Minutes of L-N/LBT Regular Teleconference

October 09, 2014; 17:00 – CEST (08:00 MST)

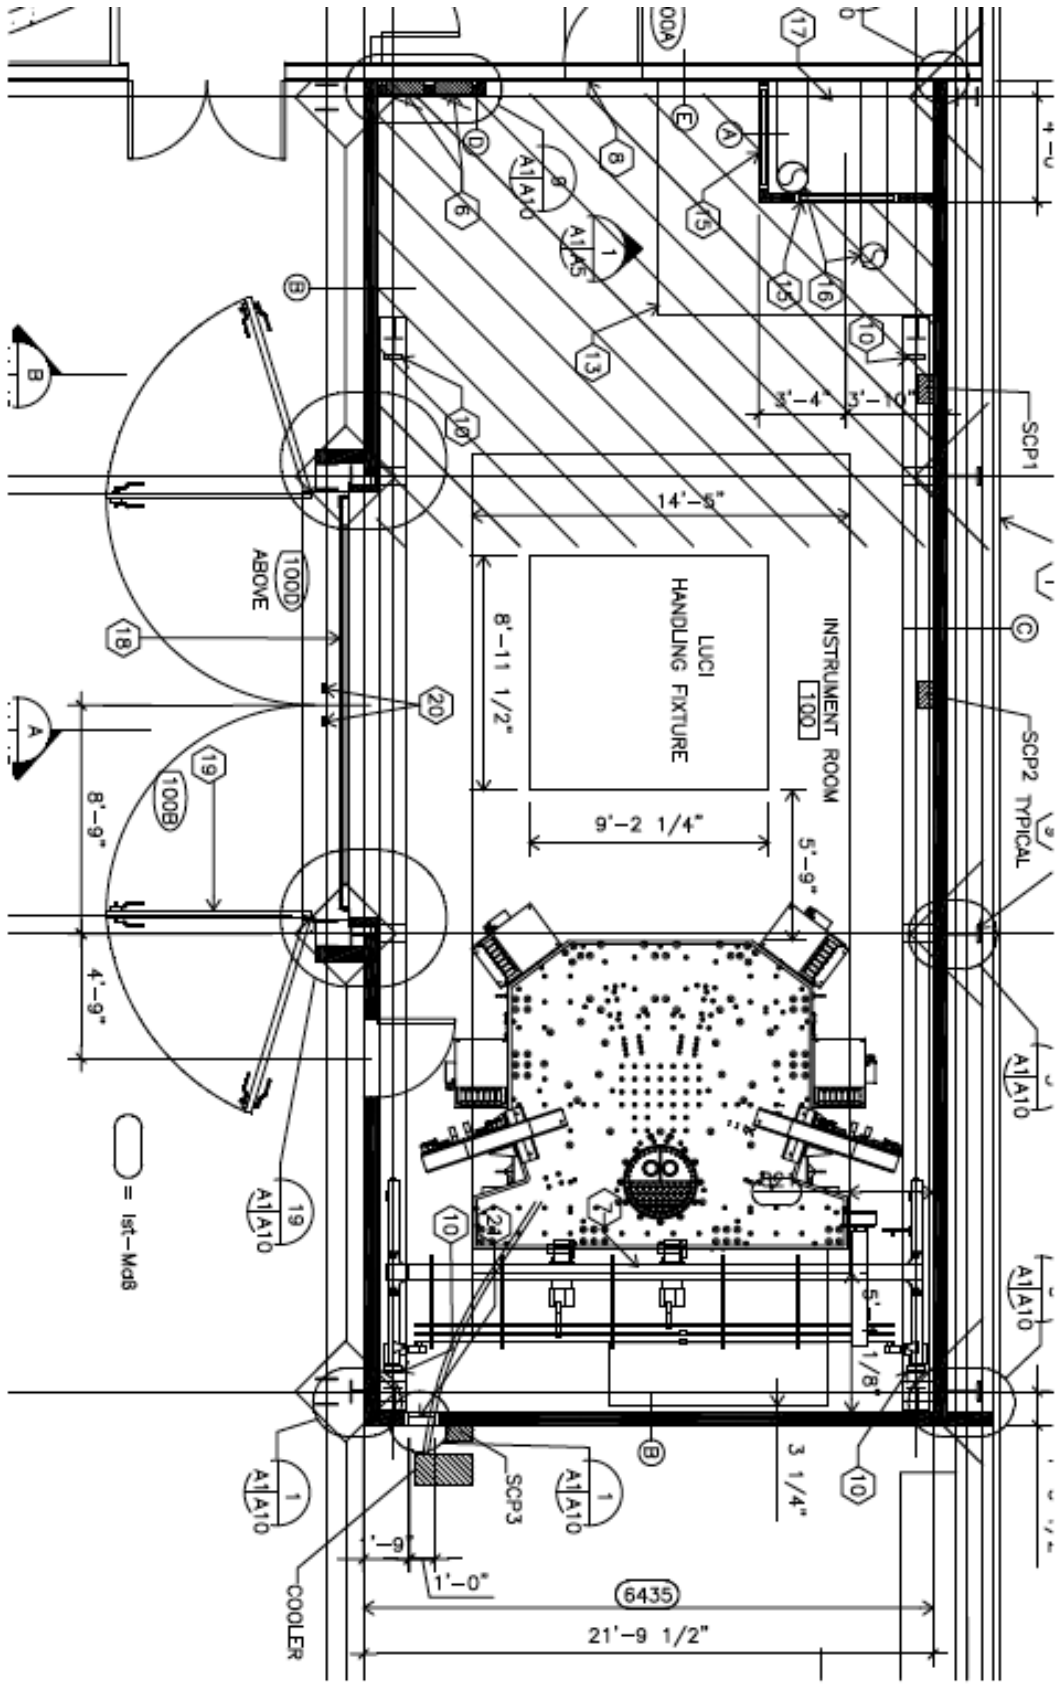
- *Clean Room Choreography*
We looked at the drawing provided by Ralph (attached below) and the note Al sent out last week. There are still many out-standing questions:

- i. Can the LUCI lid and radiation shield be stored outside the clean room?
 - ii. Dave pointed out that for some interventions, LUCI itself comes off the integration stand. Could the two, LUCI proper and the remainder left on the integration stand, fit side-by-side along the width of the clean room?

- iii. Once we complete the exercise to see how much space is required, will it be necessary to install some additional room in the high-bay? *[After the meeting, in response to checking the first draft of the minutes: MK & RH expressed certainty that additional high-bay space will be required. Editorial remark from Al: Answering this question should be the focus of future discussion; and, if we do need a high-bay structure, what crane capability should it provide?]*

- iv. Tom pointed out that we have to plan for the cooler and helium bottles. Is there space between the bell jar and the mountain lab?
 - v. Power for the cooler is needed, which might conflict with a LUCI servicing. The power requirements for L-N are given

Action to AI: Generate a revision of the clean room note that will help answering the above questions in the next discussion.
